**Re: Response to Comments on Supplemental Characterization Work Plan
Section 27 Mine, McKinley County**

United Nuclear Corporation (“UNC”) is submitting responses to the comments (“RTCs”) received from the New Mexico Energy, Minerals and Natural Resources Department’s Mining and Minerals Division’s (“MMD”) on UNC’s Supplemental Characterization Work Plan (“Work Plan”) for the Section 27 Mine (Stantec, October 2023). The Work Plan was submitted to MMD on October 31, 2023, and UNC received MMD’s comments on February 5, 2024. UNC’s responses to NMED’s comments are set forth below, preceded by a restatement of each comment.

Title
Section 27 Historical Background and Borrow Areas

Figure No.
1

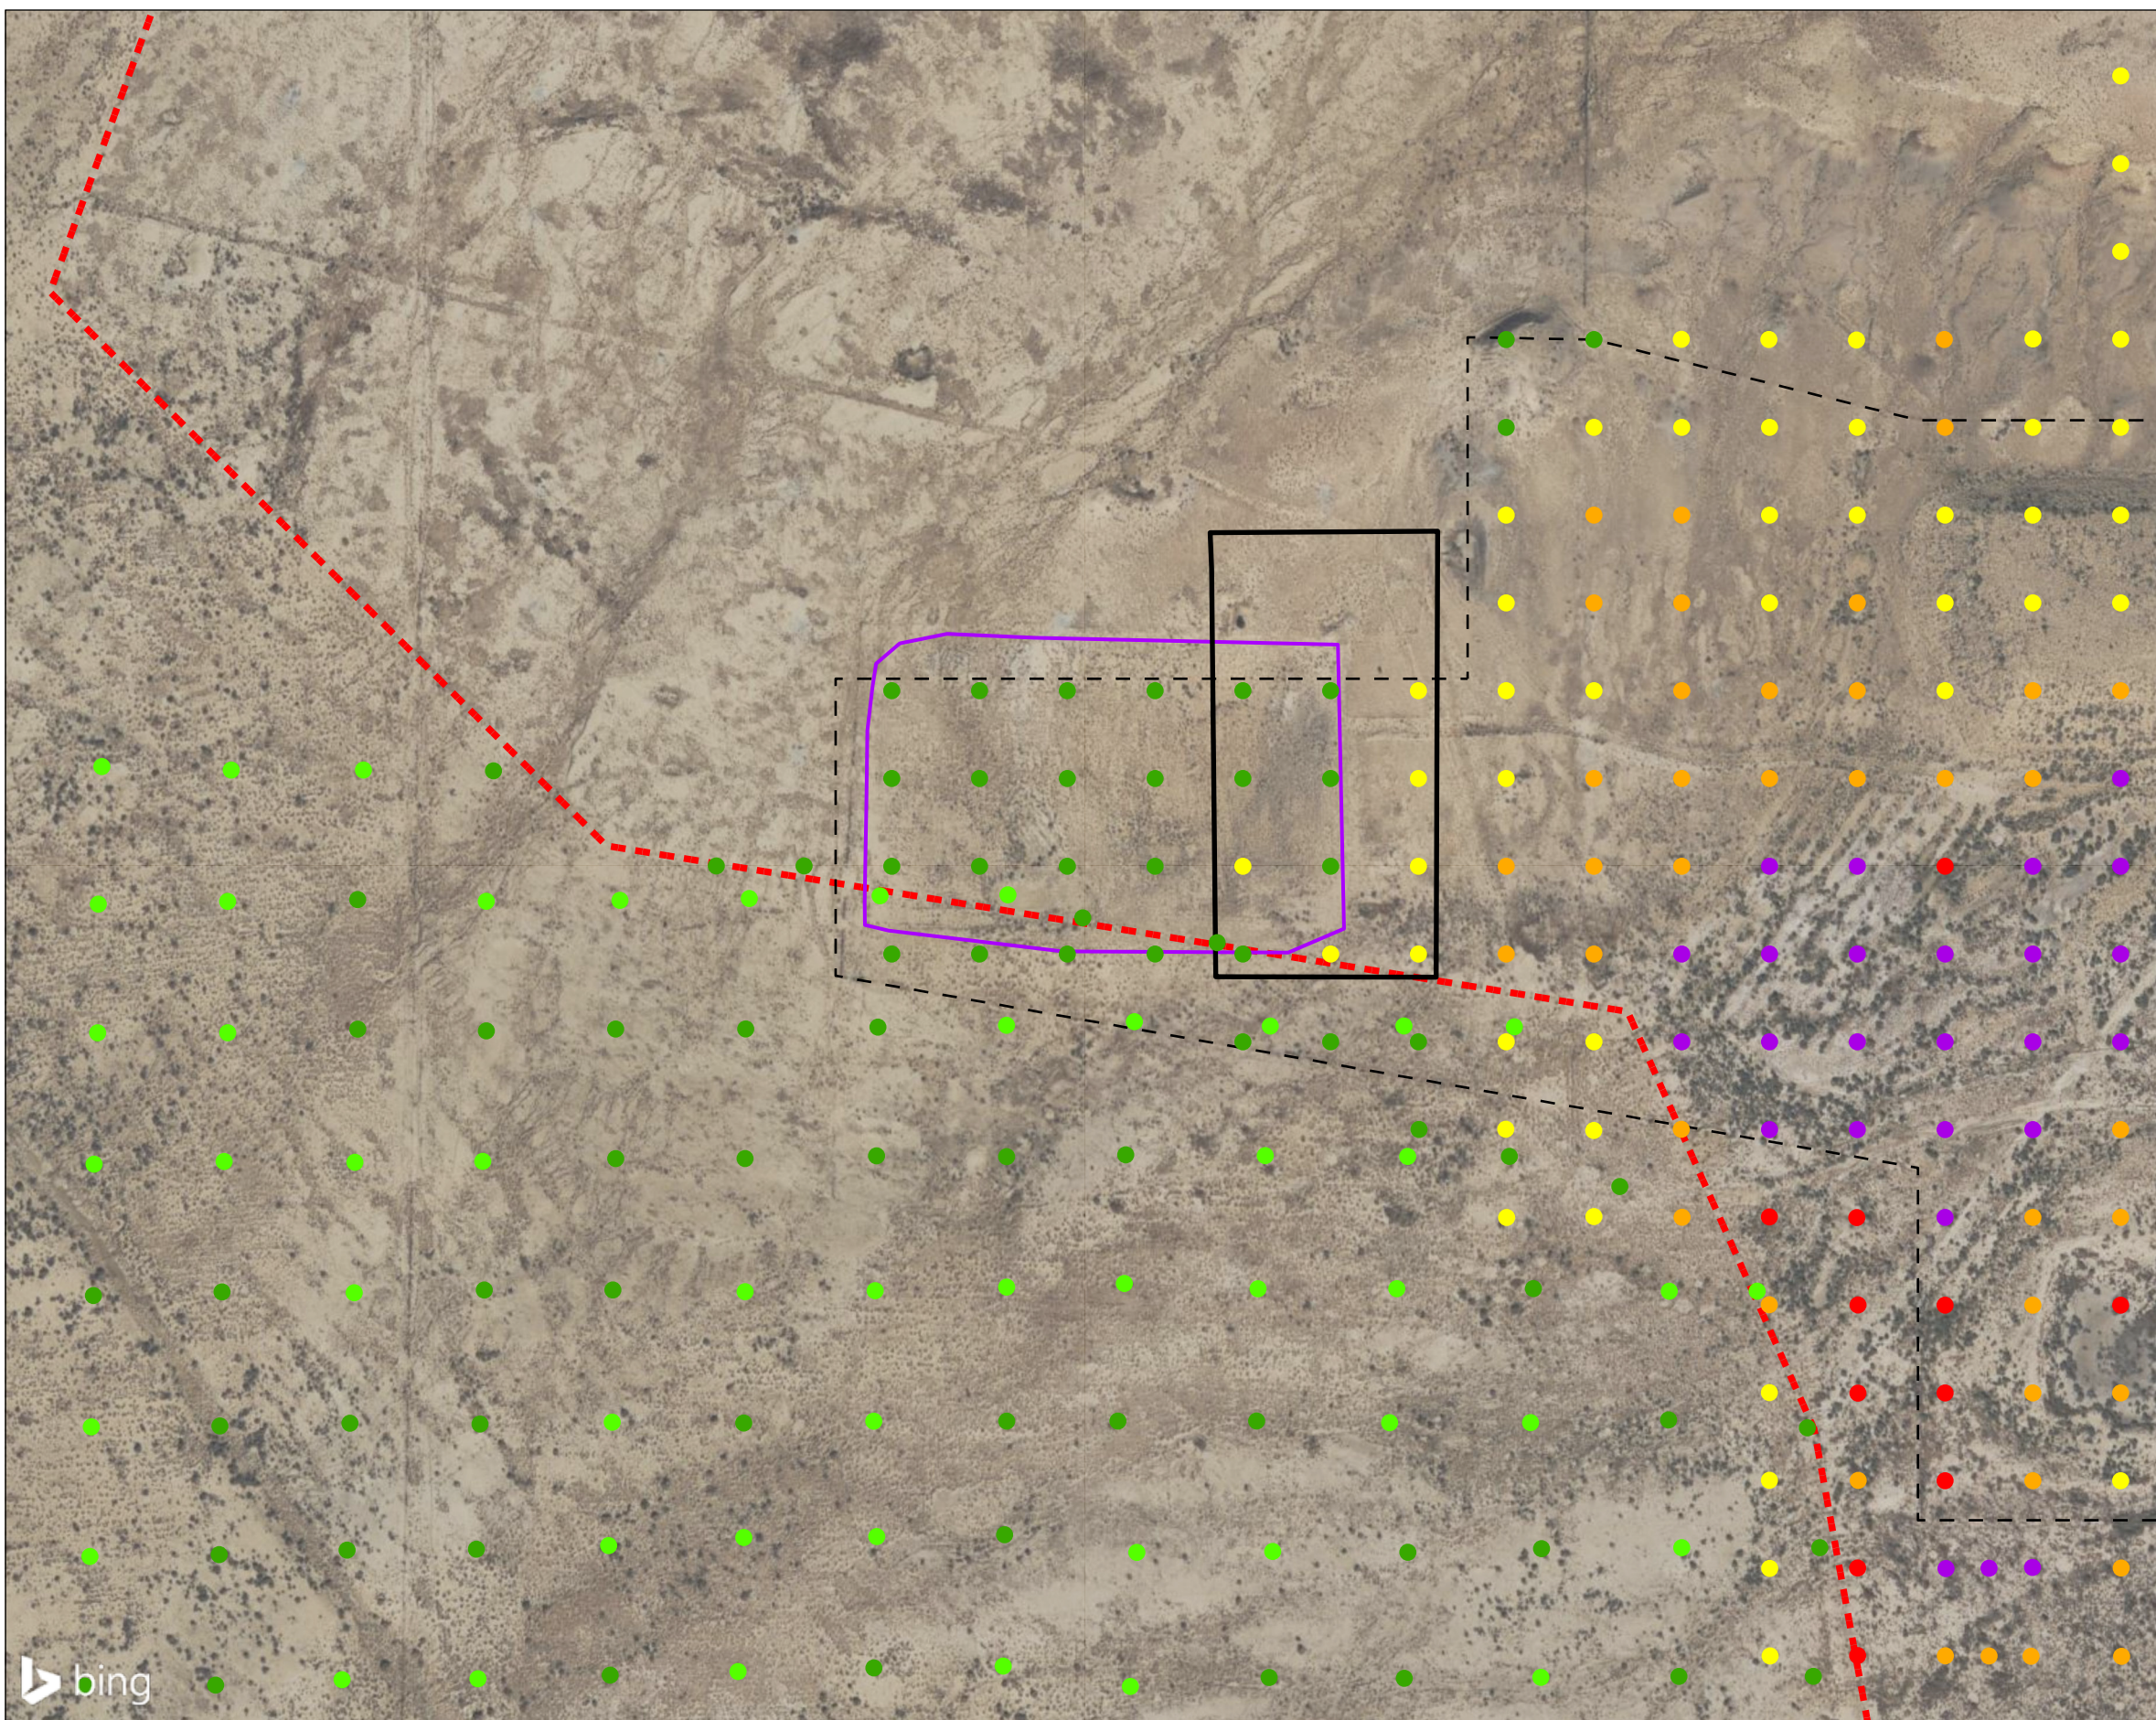
Comment 4: Please provide a map that shows the location of the proposed borrow area.

Comment 2. Section 2.1, Page 4 – NMED and MMD have previously approved a site background and reference area. Please provide the new evidence that suggests the reference area is not representative of background concentrations.

Response: Attached is a figure showing the borrow area used during 2010 reclamation activities at Section 27 (Figure 1). UNC plans to modify the Work Plan to include a figure showing the location of the proposed borrow area.

Response: The prior site background area is located partially within the limits of the DOE Phillips Mill wind-blown material cleanup area and partially within the impacted area at the Section 27 Mine (see Figure 1). Our review of the prior scanning results from this background area indicates that the estimated mean Ra-226 concentration is 6.1 pCi/g. Based on this information, the prior site background area is not considered representative of natural background.
